Porsche Carrera Cup France 2026

Note Technique 07/2026

POSITIONNEMENT DE L'ACCELEROMETRE ABS

ABS ACCELEROMETER INSTALLATION POSITION

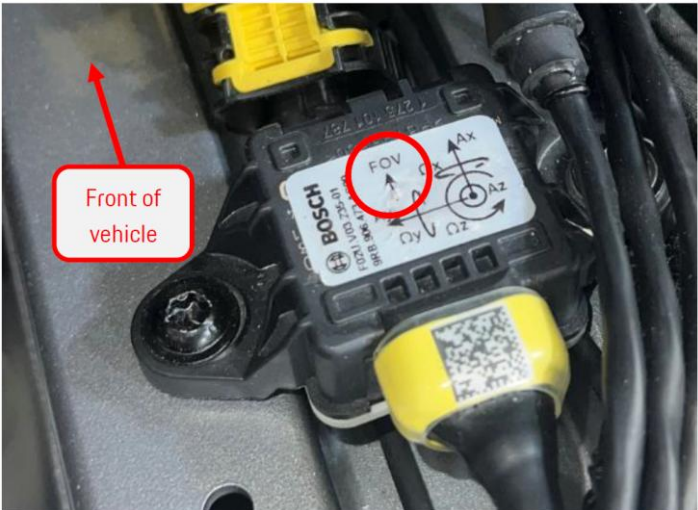
Porsche Motorsport informs that in vehicles equipped with ABS, incorrect installation of the accelerometer can cause the ABS to behave in an unintended manner.

The accelerometer is mounted on the center tunnel. During installation, it is essential to ensure that the arrow labeled “FOV” (Front of vehicle) on the top of the sensor points toward the front of the vehicle.

An incorrect installation position will result in inaccurate measurement of vehicle acceleration and may negatively affect the function of the ABS system. In this case, brake pressures will also no longer be displayed in the data or on the display.

- Before the next operation of the vehicle, verify that the ABS accelerometer is installed in the correct position
